**CITY OF CALLAWAY  
PAVING IMPROVEMENTS  
BID NO: PW2022-12**

**ADDENDUM #5**

Date Issued: July 19, 2022

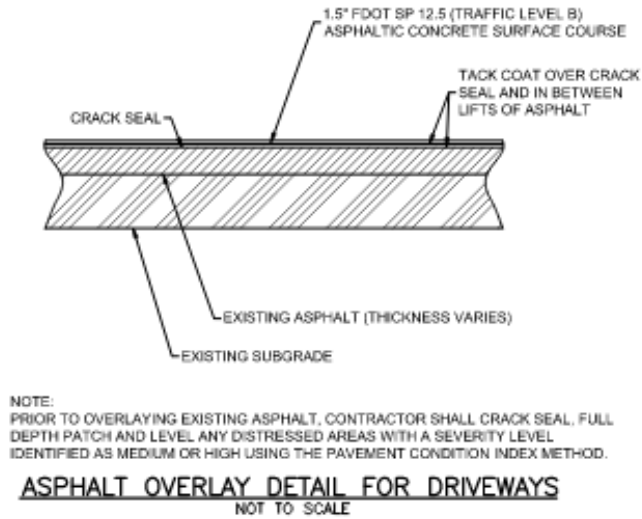
13. In the detail below, the note says to overlay, crack seal, full depth patch and level can you show on the plans which location needs which activity before overlaying occurs?

**A. All existing asphalt driveways shall have simple 1.5” of asphalt overlay and all new proposed asphalt driveways shall have 6” of base and 1.5” of asphalt. There is no full depth reclamation or crack seal of any driveways**
